DOCKET: EPA-HQ-OAR-2001-0012-0774

EPA REVIEW OF DOE PEER REVIEW OF CONCEPTUAL CHANGES INCORPORATED IN THE APPA MODEL

April 2023

Figure 2 Refined BRAGFLO-DBR grid

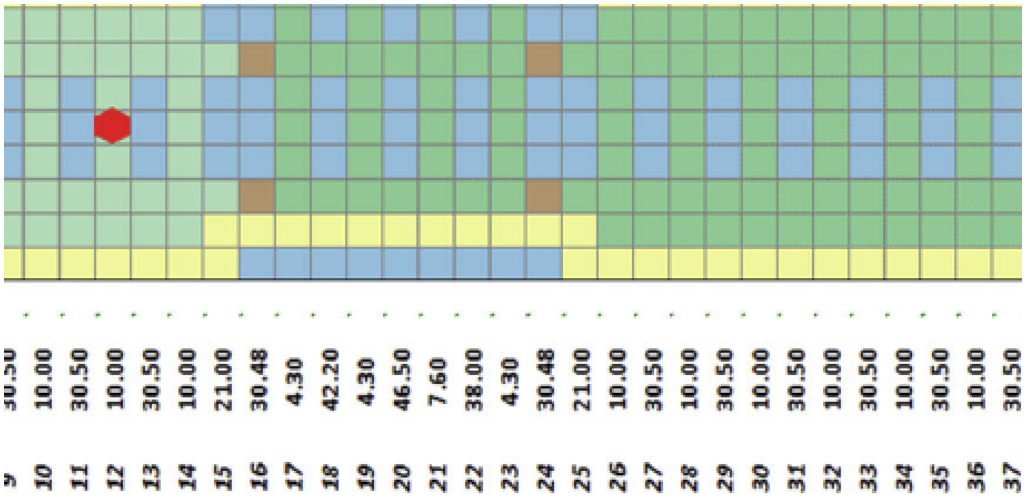
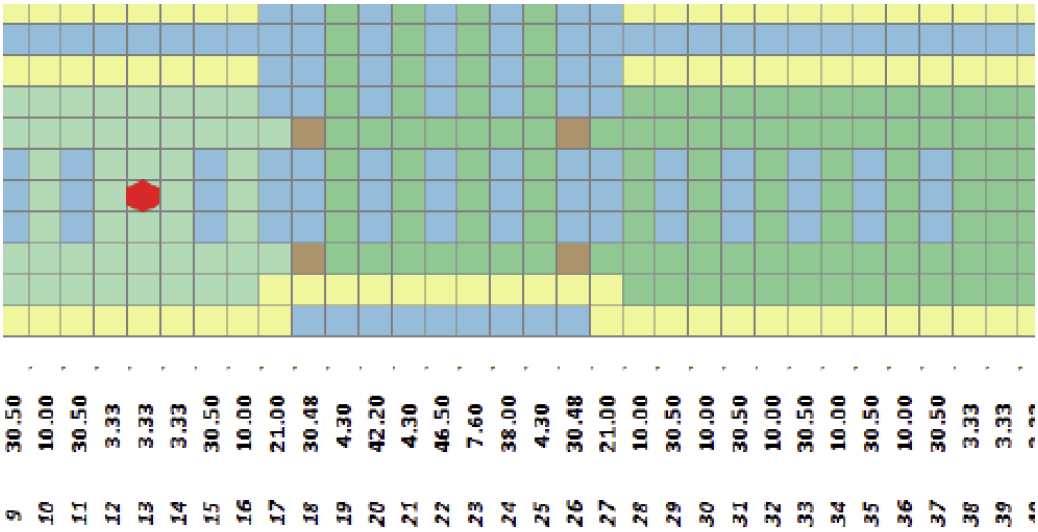
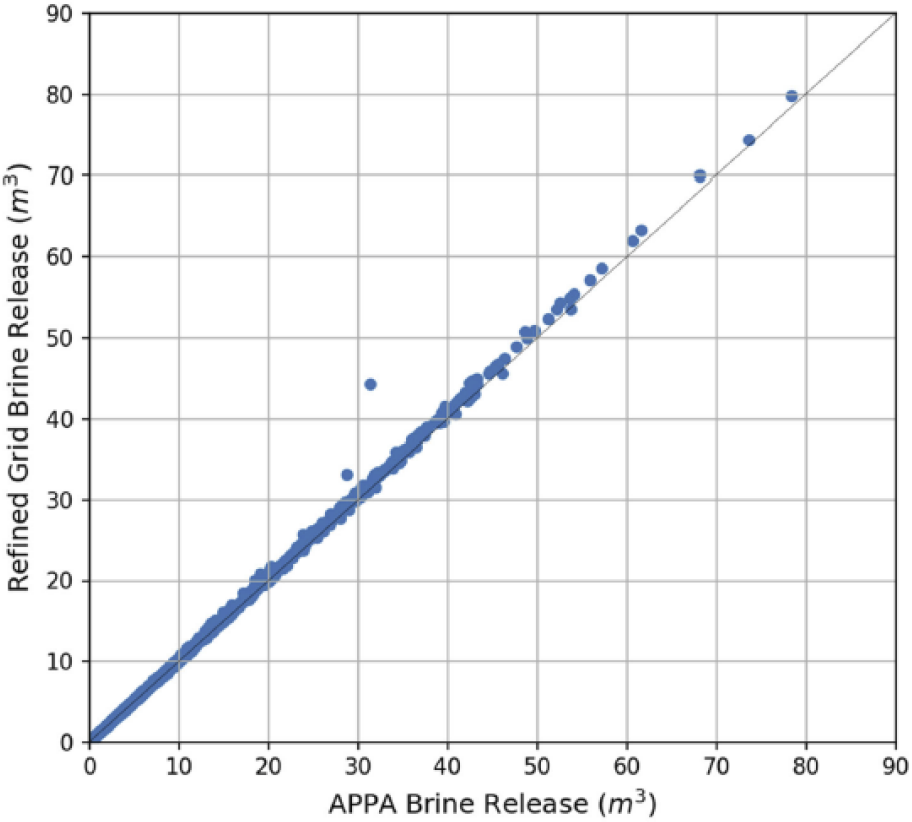
"At the request of the Peer Review Panel, King (2021e) conducted supplementary numerical simulations with a refined grid where the single column of grid cells that made up a room with a wellbore intrusion in the APPA grid was split into three columns of grid cells with the wellbore intrusion placed in the center column…" (Falta et al. 2021, p. 22).

The refined grid shown above indicates slightly higher releases than the APPA analysis for most events.

Although the small differences in releases resulted in a slight increase in mean DBR releases and in total releases at low probabilities, the refined grid results are materially the same as the coarser grid.
